National Highways Planning Response (NHPR 24-02) Formal Recommendation to an Application for Planning Permission

National Highways Reference: NH/24/05099

Location: Land at East Road, Egremont

Proposal: Demolition of existing buildings and erection of a discount food store, alterations to vehicular and pedestrian access, provision of car and cycle parking, servicing area, hard and soft landscaping and associated works.

The Image below identifies the route of the drainage pipe.

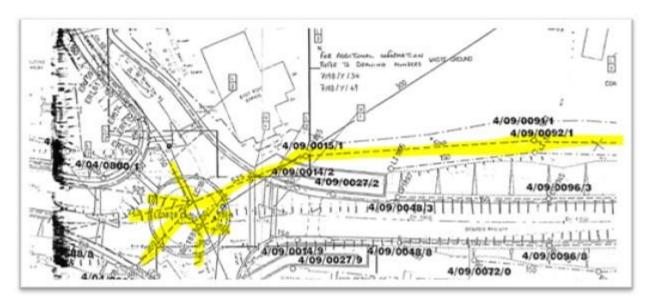
This roundabout is associated with an existing flooding hotspot, and National Highways' drainage currently discharges into the Local Authority's network through a 500mm diameter pipe running through the proposed retail development site. However, there is no conflict between the two, and National Highways is satisfied with the proposal.

Based on the additional information provided, the developer has proposed to remove the connection from their site to the highway's drainage, which National Highways also finds acceptable.
